TENNESSEE VALLEY AUTHORITY

April 23, 1986

In response to your letter to H. G. Parris dated July 22, 1985, the submittal for the Watts Bar Nuclear Plant concerning the Procedures Generation Package (PGP) is enclosed. It includes the reply to your questions, the revised PGP, and Writers' Guide.

ATTACHMENT
RESPONSE TO NRC
SAFETY EVALUATION REPORT (SER)
FOR
THE WATTS BAR
PROCEDURES GENERATION PACKAGE

FIGURE 5
STATUS TREE

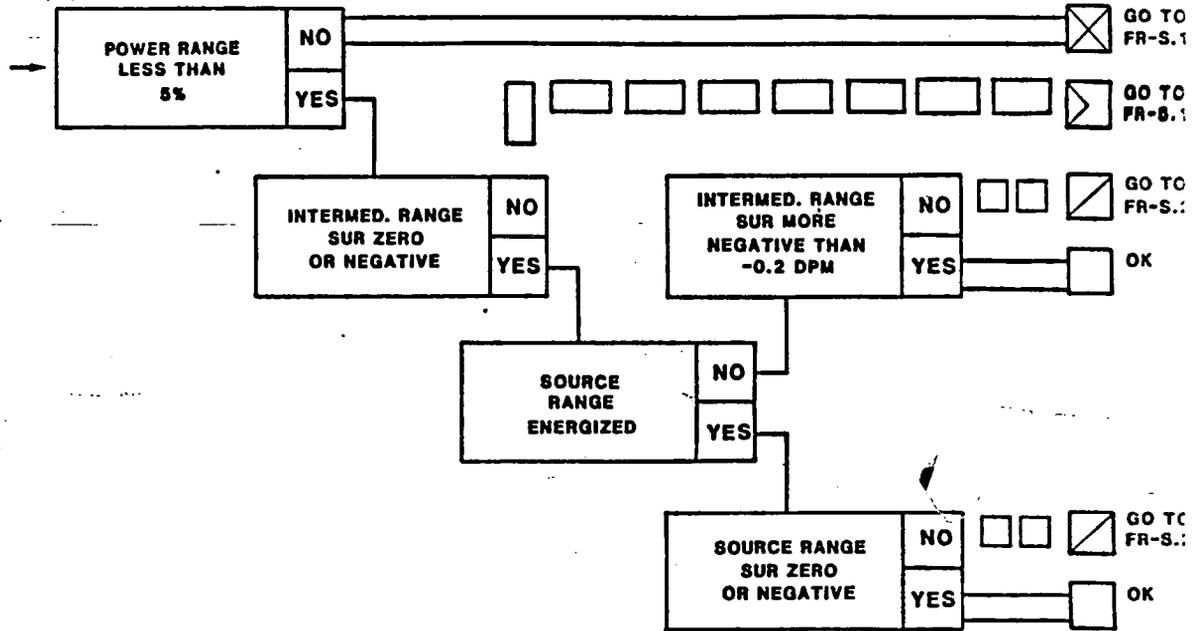
WATTS BAR RESPONSE TO WG.15 - The Writers' Guide has been revised to reference an example of the status tree format (see Figure 5). Section E states that the status tree content should be consistent with the generic guideline.
